URBAN DESIGN COMMISSION APPLICATION

Title: 929 East Washington Ave. Hotel

We are pleased to submit the attached application requesting a minor alteration to the approved Conditional Use for the 929 East Washington Avenue Hotel development. This request seeks approval for modifications to the exterior materials and sixth-floor outdoor terraces. These changes are intended to enhance maintainability and extend the longevity of the building's façade, while preserving the original design intent.

1 6TH FLOOR NORTH ROOF TERRACE PLAN

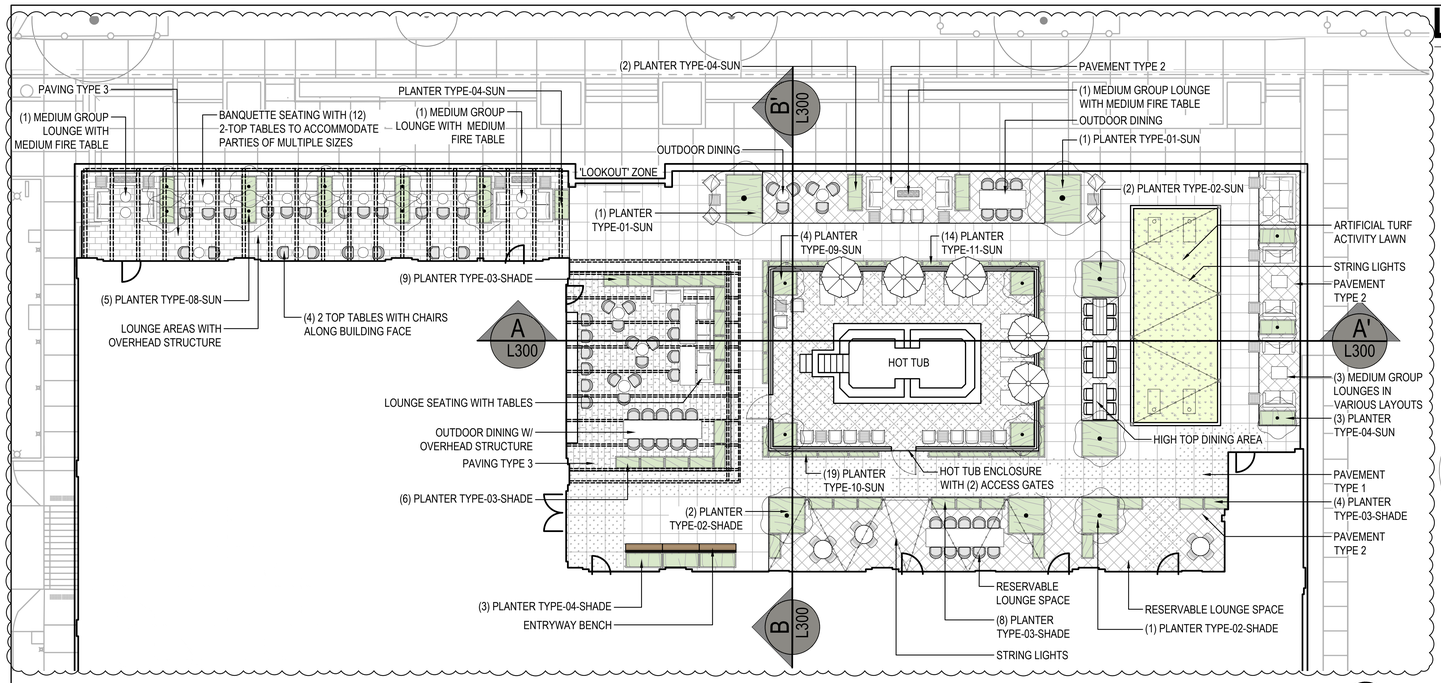
6. Sixth-Floor Outdoor Terrace Modifications
   - Northern terrace seating and planter layouts have been revised to improve circulation and increase outdoor seating near the restaurant.

- The open trellis over the eastern restaurant seating area will be covered with a translucent glazed canopy for weather protection and enhanced usability. The canopy structure will be aluminum or painted steel.
- Grill stations on the southern terrace have been reoriented and reconfigured to include an island for additional counter space and seating.
- Door locations accessing the terraces have been adjusted to align with updated circulation paths.
- The exit stair enclosure on the north terrace has been revised to match adjacent exterior materials.

1 6TH FLOOR SOUTH ROOF TERRACE PLAN

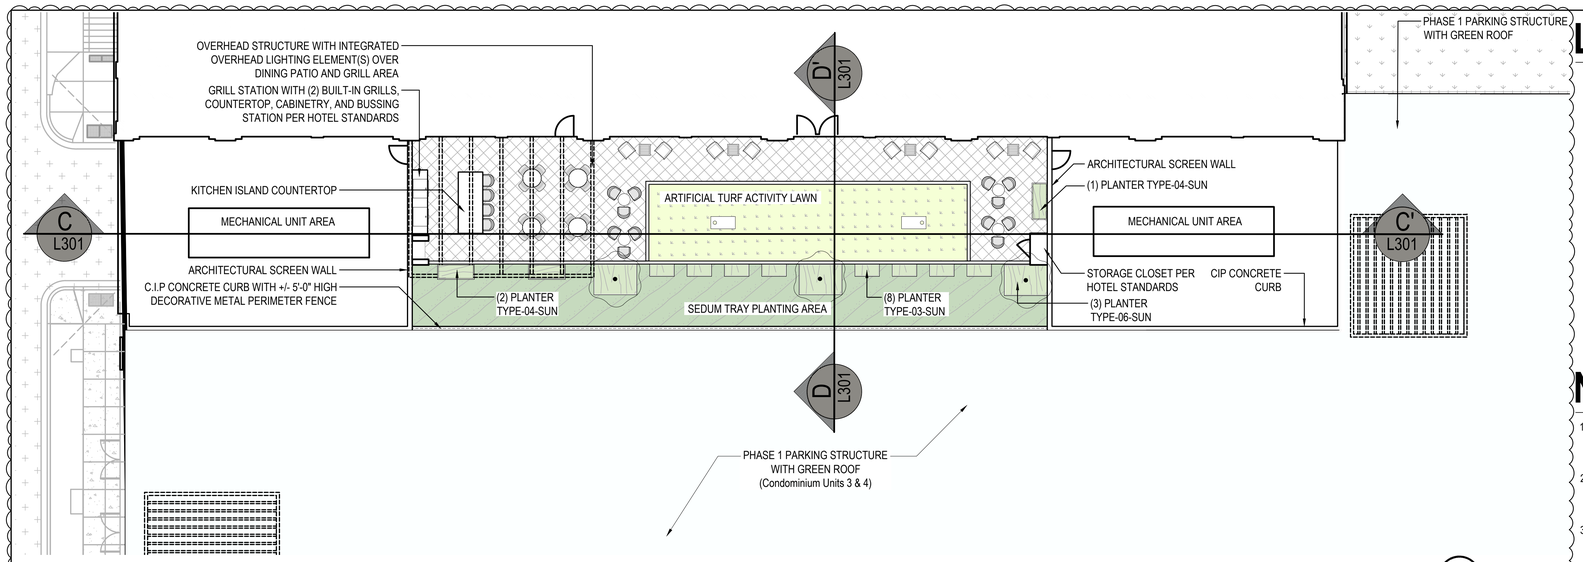
8. Rooftop Mechanical Enclosures
   Two enclosures have been added to screen mechanical equipment on the east and west ends of the southern terrace. These are composed of brick-clad piers and painted ribbed metal panels, consistent with the overall aesthetic. The displaced green roof area will be relocated to the level 15 roof.
